TECHNICAL BULLETIN
J047 UPS8014-3bNAS1
31 OCT 2014

Update Prior to Sale: Seat Belt Tensioner System Connector Wiring

F-TYPE (X152)

Model Year: 2014-2015
VIN: K00074-K19728

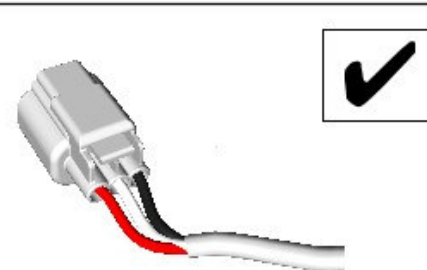
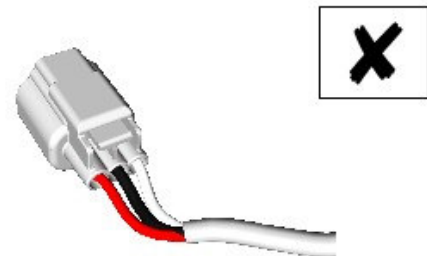
5. At the Seatbelt Tension Sensor side of connector C3R210, check that the electrical connector wires are positioned in the correct pin location as shown.

- If the wires are in the correct position, reverse steps 1-4 and release the vehicle.
- If the wires are not in the correct position, proceed to step 6.

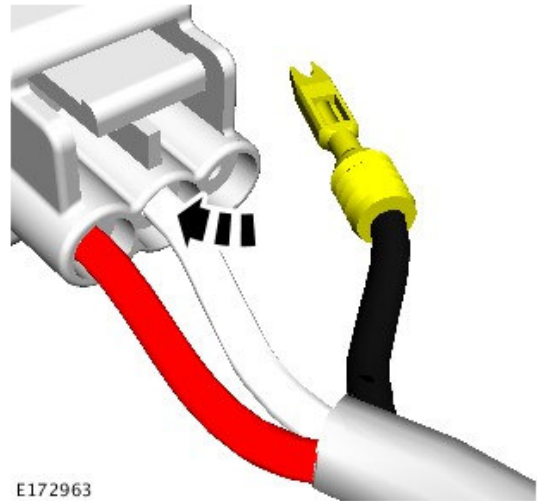
12. Install the white wire electrical pin into the center socket on the electrical connector.

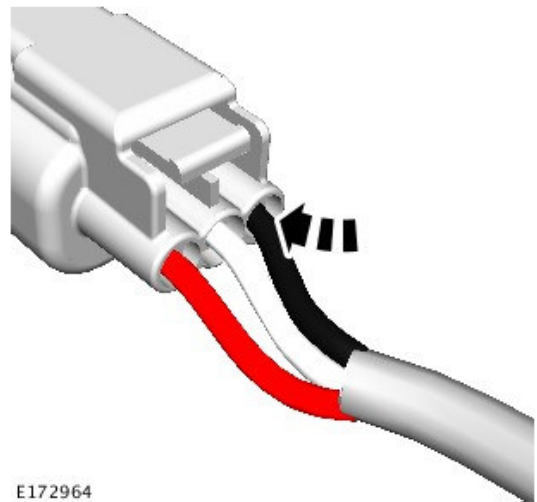
13. Install the black wire electrical pin into the right-hand-side socket on the electrical connector.
